Site: VILLAGE OF KING  
Lot: 4-19  
Model: KENNEDY TH-07 (A1 END)  
Purchaser: MATTHEW & CHANTELE VANELLI  
Phone: 647-505-8172  
Phone/Email: [colomboc11@gmail.com](mailto:colomboc11@gmail.com)

CONSTRUCTION SUMMARY OF EXTRAS  
Printed 2020-10-20 / 8:36 AM / Page 2 of 2

ZANCOR  
HOMES

INSULATION

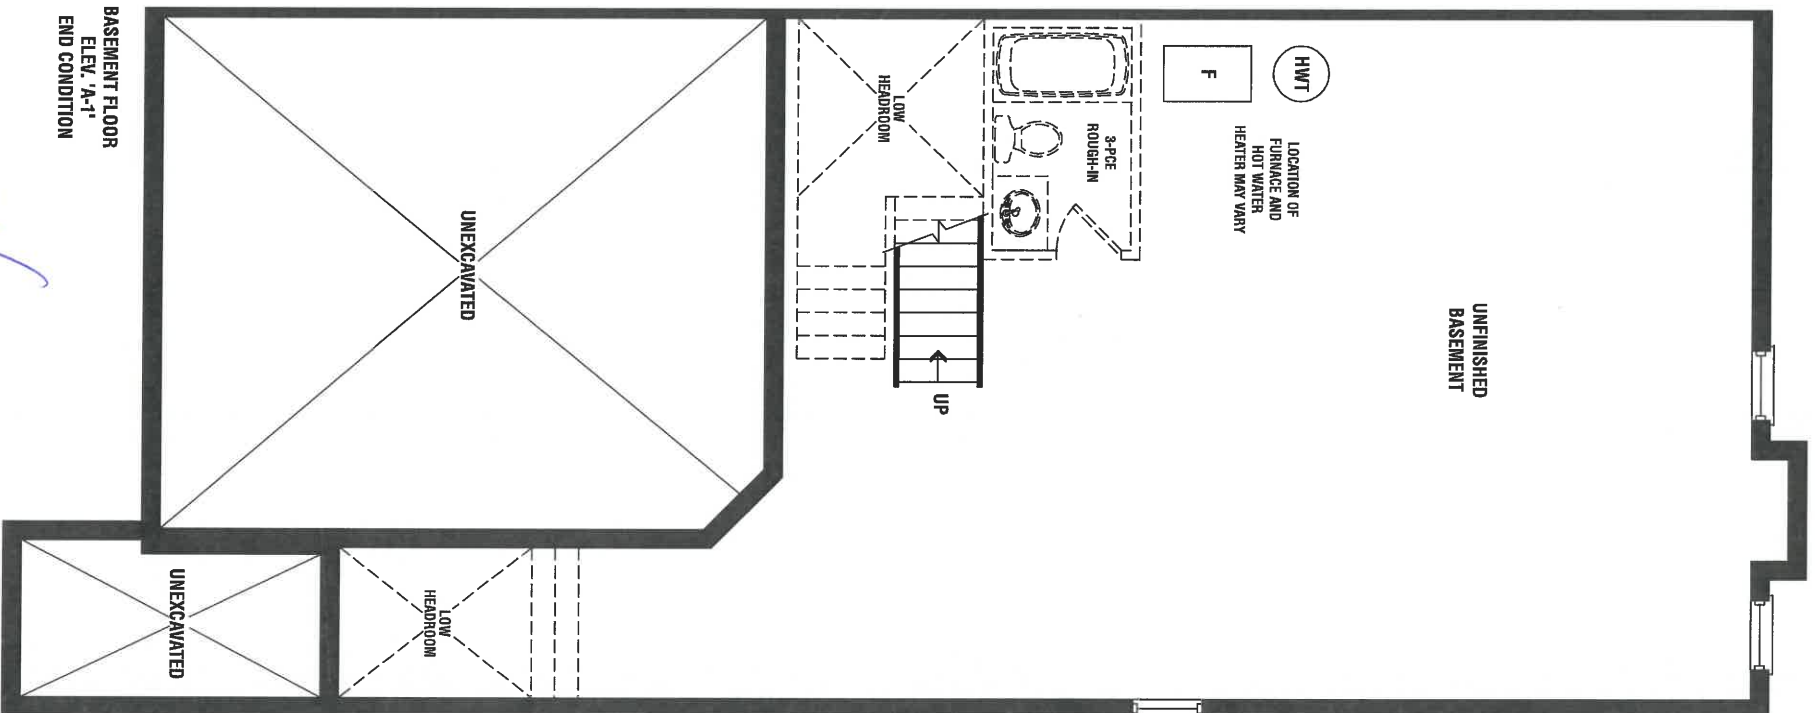
#24 HVAC - LENNOX HUMIDIFIER WB3-17	JANUARY 21 2020
#25 INSULATION - BETWEEN M/E * MASTER BED, POWDER ROOM, BED 2 & 3, LAUNDRY - SEE SKETCH	JANUARY 21 2020
MASTER ENSUITE	JANUARY 21 2020

## ENSUITE PLAN

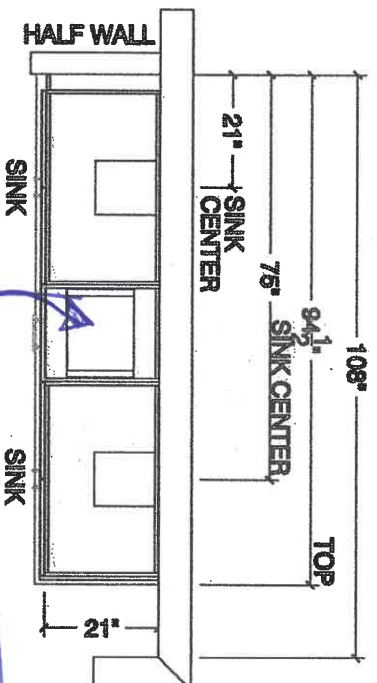
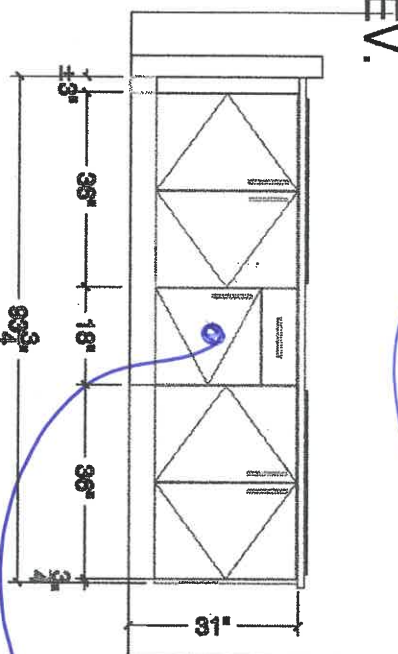
#31 CABINET - MASTER ENSUITE - ADD BANK OF DRAWERS, SOFT CLOSE, 3 EQUAL DRWS	JANUARY 21 2020
MAIN BATH	JANUARY 21 2020
#32 COUNTERTOP - MAIN BATH - UPGRADE TO COMPAC QUARTZ, UPGRADE 3 *INCLUDES (2) OVAL UNDERMOUNT SINKS	JANUARY 21 2020
LAUNDRY	JANUARY 21 2020

3 EQUAL  
BANK OF DRAWERS  
Soft Close

## LAUNDRY PLAN

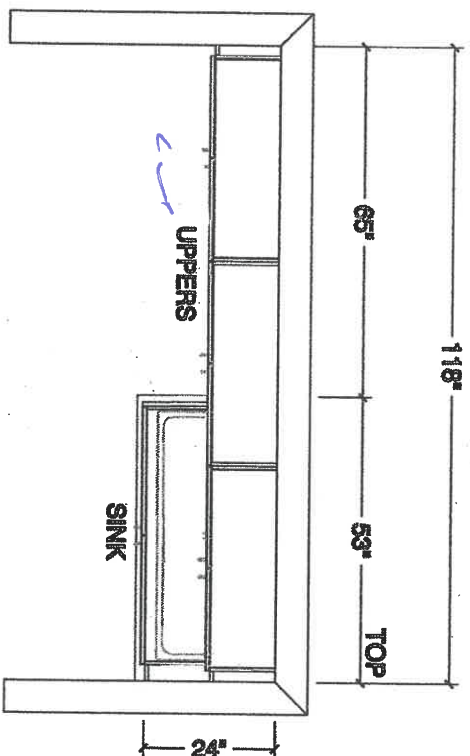
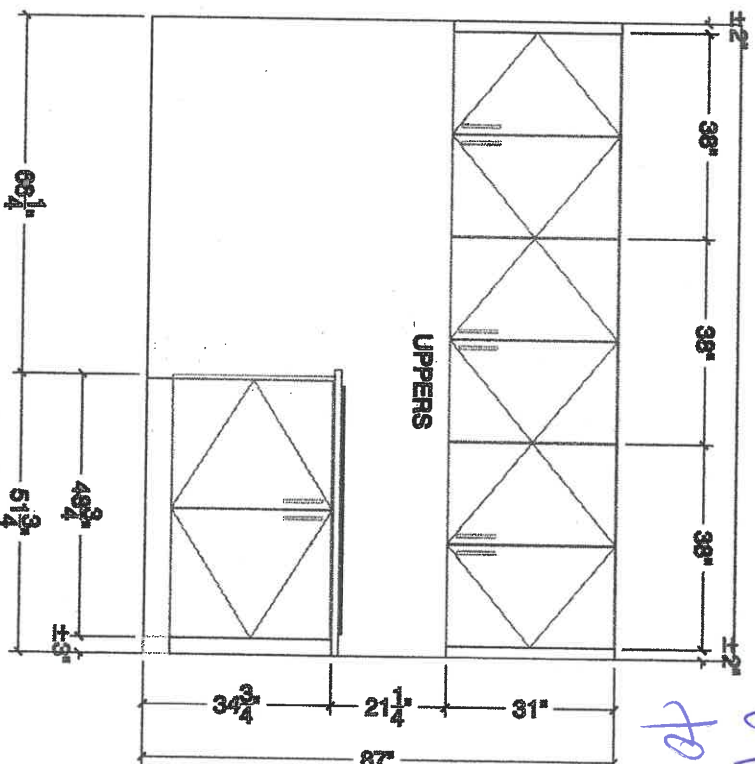
#33 COUNTERTOP - LAUNDRY - UPGRADE TO COMPAC QUARTZ, UPGRADE 3 **INCLUDING TO GO ACROSS/ABOVE WASHER AND DRYER	JANUARY 21 2020
#34 SINK - LAUNDRY - UPGRADE TO UNDERMOUNT SINK, BLANCO STELLAR 441398 & MOEN RILEY FAUCET	JANUARY 21 2020

#35 CABINETS - LAUNDRY - ADD UPPER CABINETS, CATEGORY 1, EXTENDED TO CEILING	JANUARY 21 2020
#36 CABINETS - LAUNDRY BASE, UPGRADE CATEGORY 1	JANUARY 21 2020
